SUBJECT: ST. LUCIE PLANT, UNIT NO. 2 - ISSUANCE OF AMENDMENT NO. 206 TO REPLACE THE CURRENT TIME-LIMITED REACTOR COOLANT SYSTEM PRESSURE/TEMPERATURE LIMIT CURVES AND LTOP SETPOINTS WITH CURVES AND SETPOINTS THAT WILL REMAIN EFFECTIVE FOR 55 EFFECTIVE FULL POWER YEARS (EPID L-2020-LLA-0029)

SAFETY EVALUATION BY THE OFFICE OF NUCLEAR REACTOR REGULATION

RELATED TO AMENDMENT NO. 206

ST. LUCIE PLANT, UNIT NO. 2

FIGURE 3.4-2

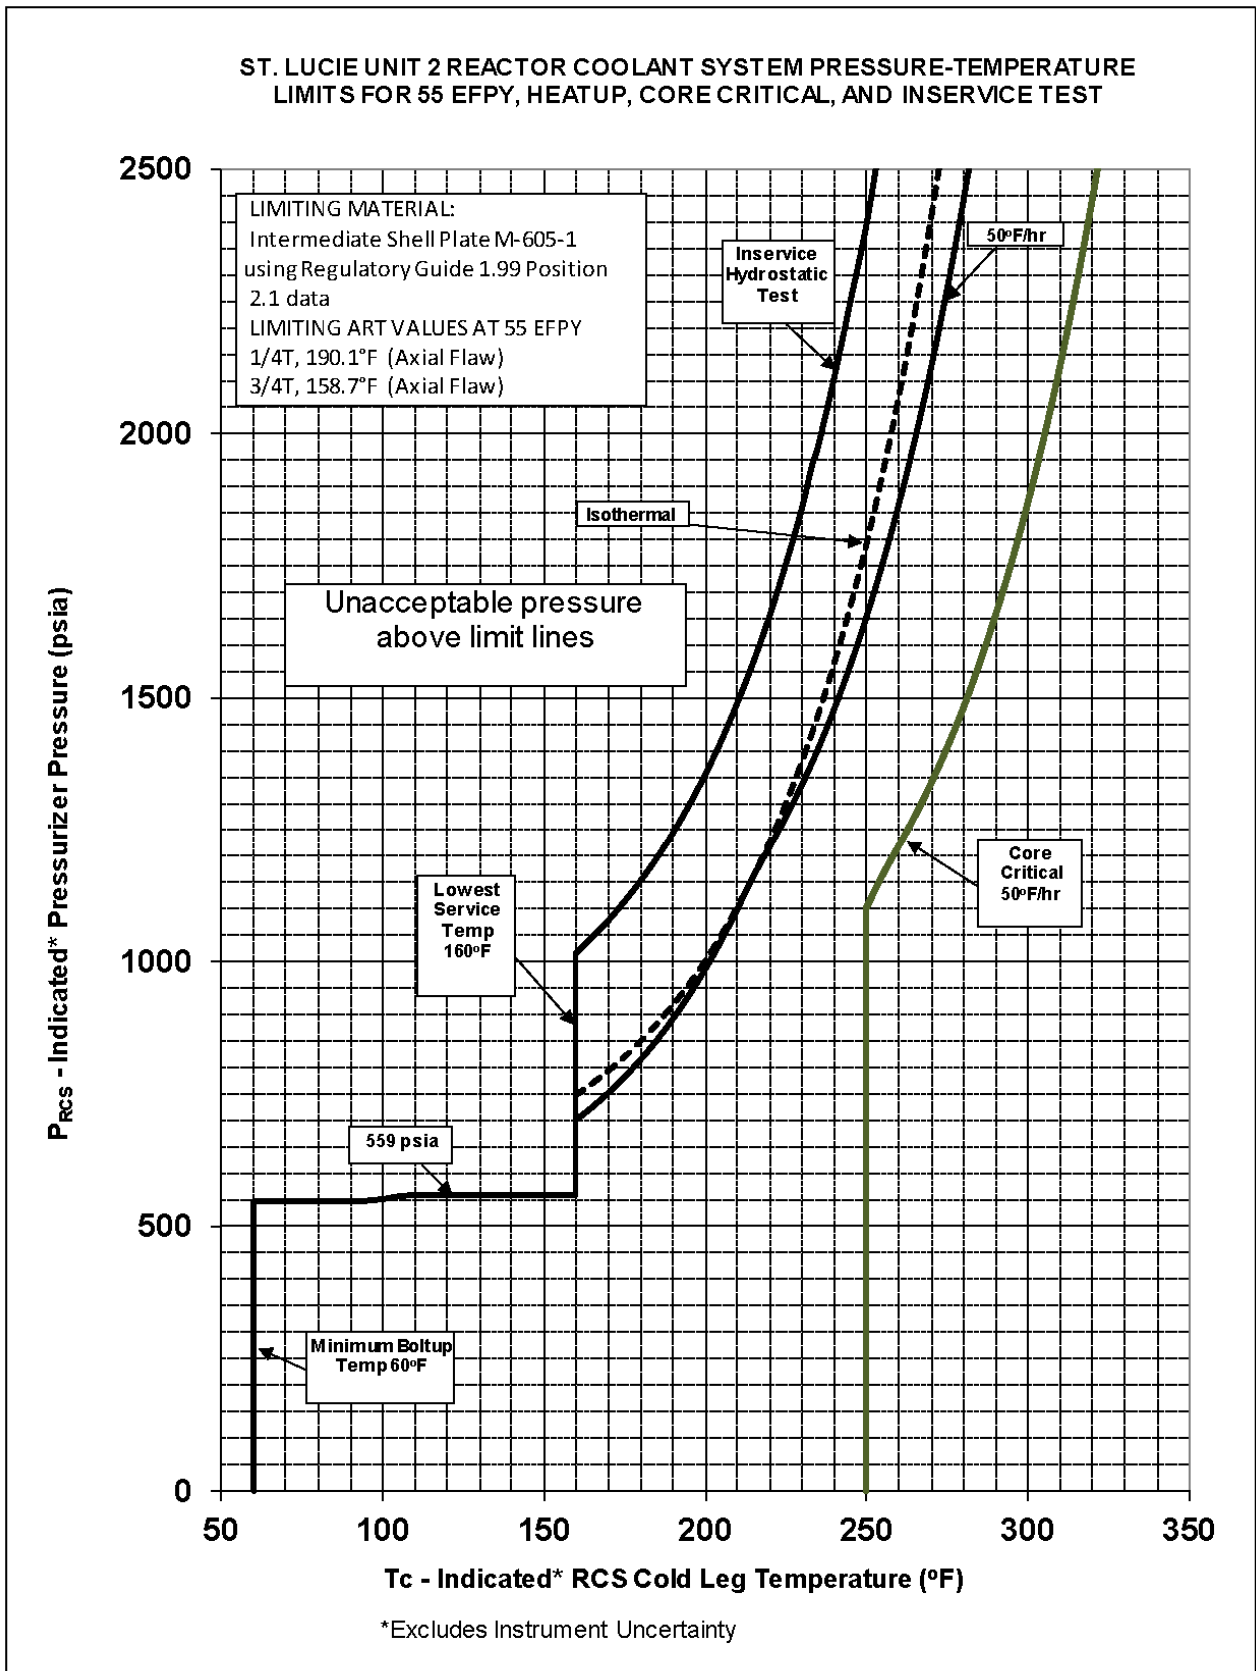
The NRC staff evaluated the licensee's proposed 55 EFPY RCS P/T limits for heatup, core critical, and inservice test shown in replacement Figure 3.4-2 in Attachment 4 of the LAR application and the proposed 55 EFPY RCS P/T limits for cooldown and inservice test in replacement Figure 3.4-3 in the same attachment. Using the limiting ART values, the staff independently calculated P/T limits based on the related equation in Appendix G to Section XI of the ASME Code. However, this was done with the thermal stress intensity factor computed from a one-dimensional thermal stress analysis across a vessel wall. The staff compared its calculated values with those in the 55 EFPY P/T limits data in Tables 7-1 through 7-3 of WCAP-18275-NP and determined that the licensee's proposed 55 EFPY P/T limits are consistent with the methodologies in Appendix G to Section XI of the ASME Code and WCAP-14040-A, Revision 4. The staff verified that the cooldown P/T limits in Figure 3.4-3 are those corresponding to the cooldown rates shown in the figure: a rate of 100°F per hour down to a temperature of 212°F and a rate of 50°F per hour down to a temperature of 60°F. In addition, based on the flange and balance of reactor coolant system RT_{NDT} values in Table 3-2 of WCAP-18275-NP, the staff verified that flange requirements of 10 CFR Part 50, Appendix G, Paragraph IV.A.2 are bounded by the lowest service temperature (LST) requirements of NB-3211 and NB-2332 of Section III of the ASME Code.

The staff noted that the y-axis of the proposed 55 EFPY RCS P/T limits in Figures 3.4-2 and 3.4-3 in Attachment 4 of the LAR application is the indicated pressure at the pressurizer. Since there is a pressure head difference between the pressure at the pressurizer and the pressure at the RPV beltline, the staff verified that the licensee applied the actual pressure correction factor (APCF) of 77.1 psi to the proposed 55 EFPY RCS P/T limits to account for the static and dynamic head difference between the pressurizer instrument location and RPV beltline. The licensee applied the APCF by subtracting 77.1 psi from the calculated allowable pressure values in Tables 7-1 through 7-3 of WCAP-18275-NP.

The licensee stated that the proposed 55 EFPY RCS P/T limits shown in replacement Figures 3.4-2 and 3.4-3 in Attachment 4 of the LAR application do not include instrument uncertainty. In Section 4.0 of Attachment 1 of the LAR application, the licensee stated that LTOP system enable temperatures and pressure setpoints included instrument uncertainties in the transient analysis performed to determine those setpoints. The NRC staff finds this acceptable since it means that instrument uncertainties would be accounted for when the LTOP system is enabled (i.e., when RCS temperatures are less than or equal to the LTOP enable temperatures). At RCS temperatures greater than the LTOP enable temperatures, the licensee stated that RCS operation below and to the right of the proposed 55 EFPY P/T limits are

As shown in the proposed TS Figure 3.4-2, during heatup, the peak transient pressure of 546.5 psia between 60°F and 200°F does not exceed the P/T limits within that temperature range. In addition, the peak transient pressure of 677 psia between the LTOP enable temperatures of 200°F and 252°F does not exceed the P/T limits within that temperature range. The staff, therefore, finds this acceptable.

administratively controlled with margins greater than the instrument uncertainty. Accordingly, the staff finds the licensee's treatment of instrument uncertainty acceptable. Based on the evaluation above, the staff finds the licensee's proposed 55 EFPY RCS P/T limits for heatup, cooldown, core critical, and inservice test of St. Lucie, Unit 2 acceptable.

FIGURE 3.4-3

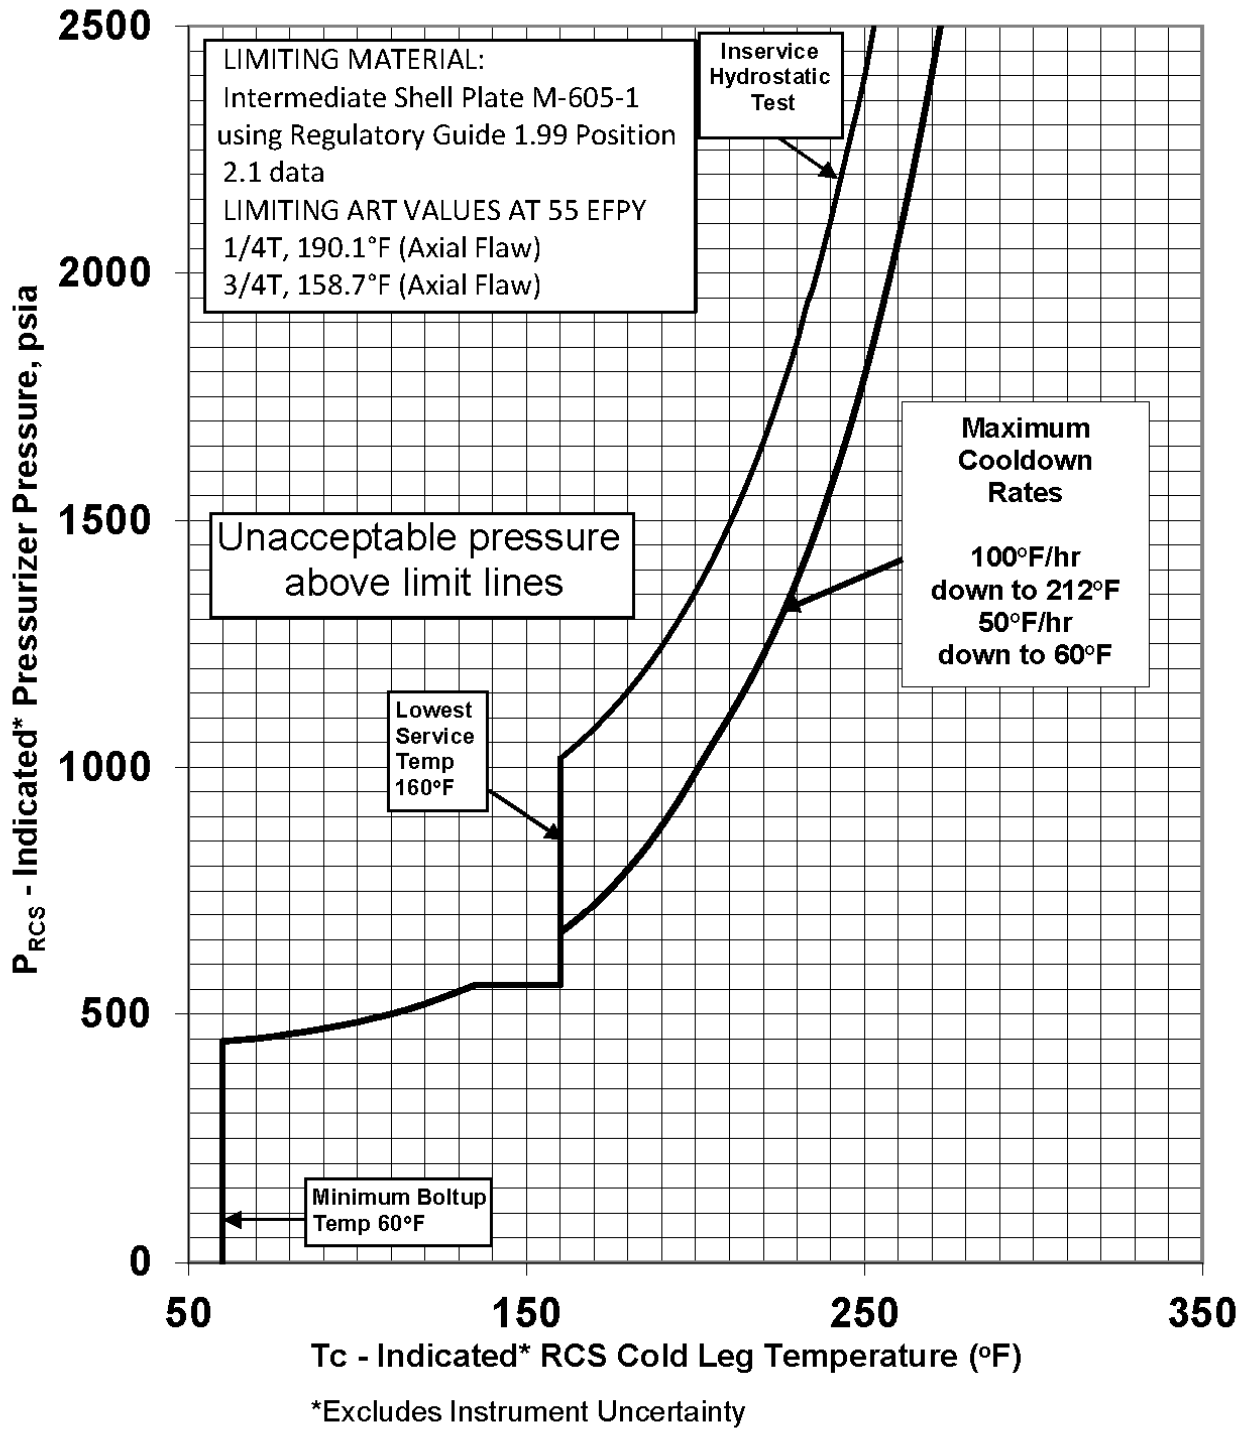
The proposed TS Figure 3.4-3 shows that during cooldown, the peak transient pressure of 546.5 psia between 149°F and 200°F does not exceed the allowable cooldown limits within that temperature range. In addition, the peak transient pressure of 677 psia between the LTOP enable temperature range of 200°F and 240°F does not exceed the P/T limits within that temperature range. Therefore, the staff finds this acceptable.
